Economic Commission for Europe
Inland Transport Committee
World Forum for Harmonization of Vehicle Regulations
Working Party on Lighting and Light-Signalling
Eightieth session

Geneva, 23-26 October 2018

Report of the Working Party on Lighting and Light-Signalling on its eightieth session
Contents

Figure 1
Example of test set-up for log-periodic antenna

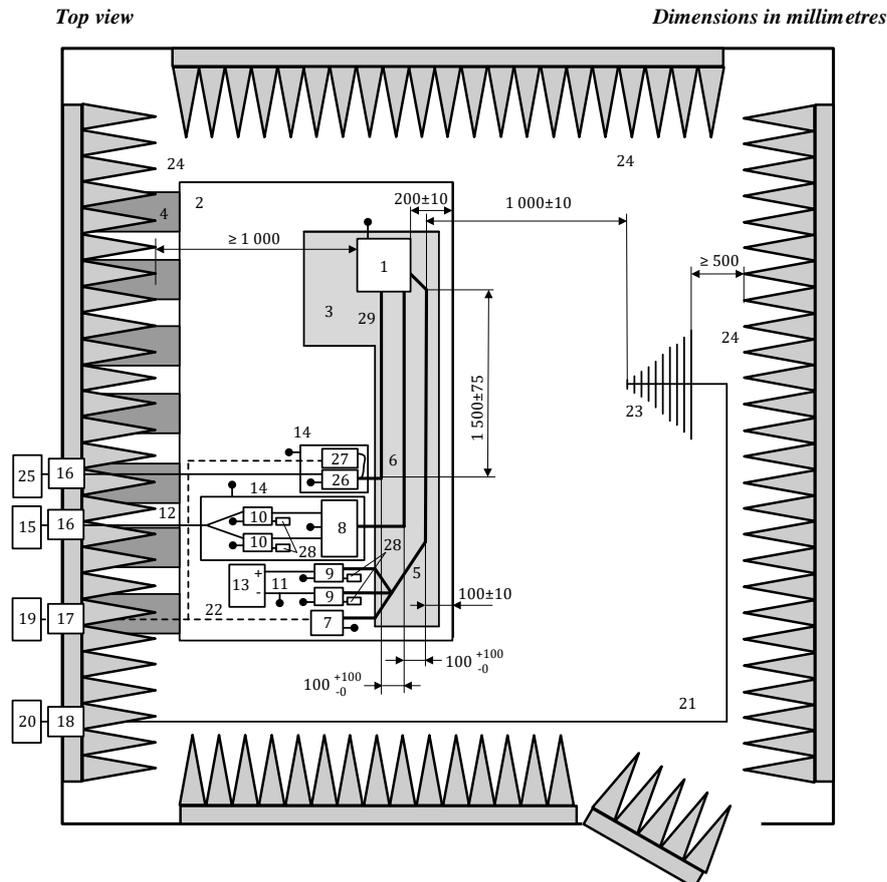
Annex 9, Appendix 3, amend to read:

Test configuration for ESA's involved in "REESS charging mode coupled to the power grid". The test shall be performed according to ISO 11452-2.
